PUBLIC COMMENT

Chris Wingert, General Manager
West Central Texas Municipal Water District
Abilene

Actual Release Rates versus the Environmental Flow Regime Recommendations from the Brazos River BBEST for the Brazos River near South Bend Gauge

USGS 15-Minute Streamflow - Brazos River at South Bend

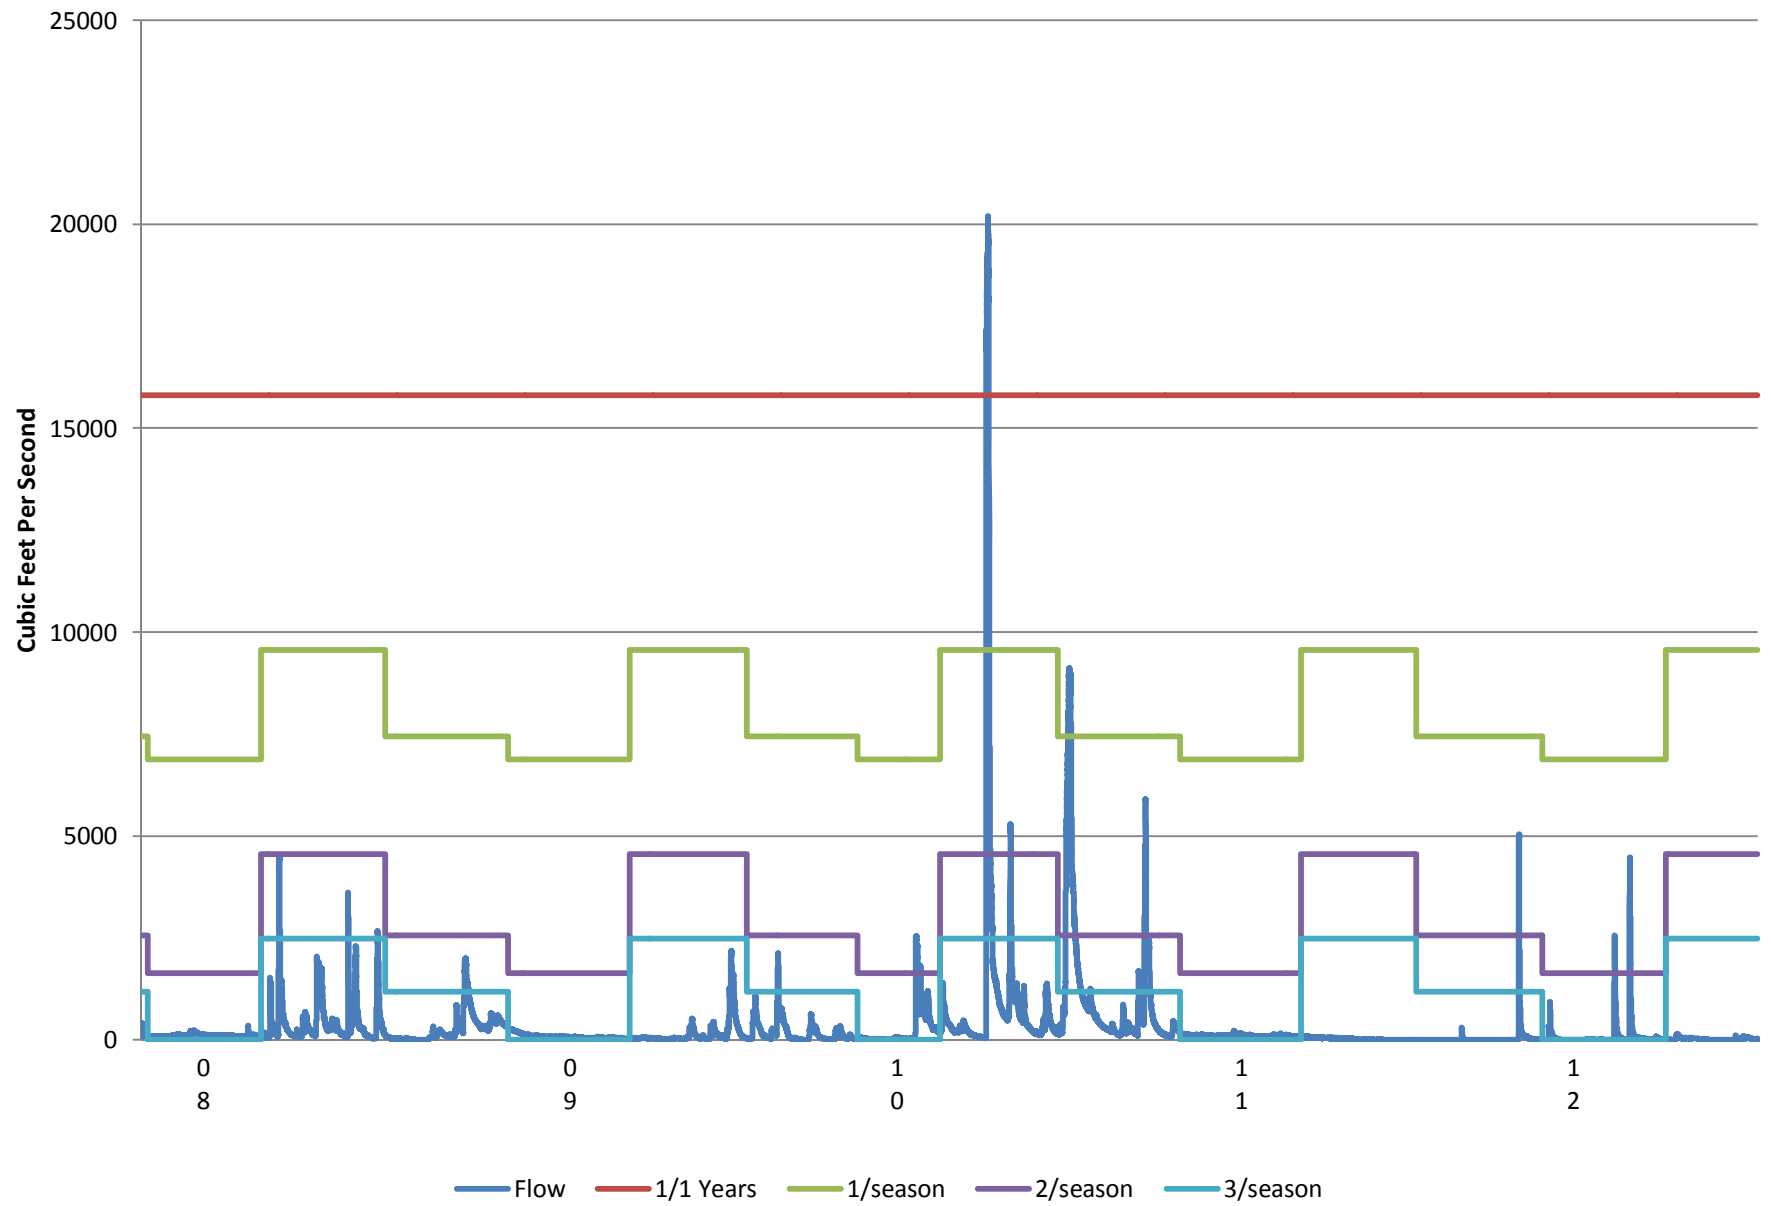
Recently I looked at the 15-minute USGS flow for Brazos River at South Bend during 2008 through 2011. Looking at the actual events passing that gauge during the last 4 years:

- 1 Overbank flow every 2 years - 0 out of 4 years.
- 1 Overbank flow every year - 1 out of 4 years.
- 1 High Pulse every season - 2 out of 12 seasons.
- 2 High Pulses every season - 2 out of 12 seasons.
- 3 High Pulses every season - 3 out of 12 seasons.

Again it appears the historic flows have been far less than the BBEST criteria for the Upper Brazos River Basin. As a result a new reservoir would have to release a large portion of inflows to meet the criteria, which at best would have a significant financial impact on the project and at worst make the project unfeasible.

I would encourage the Committee to consider reducing the BBEST recommended criteria to be more realistic with recent stream flow performance within the upper basin, and to be a manageable hardship on reservoir developers.
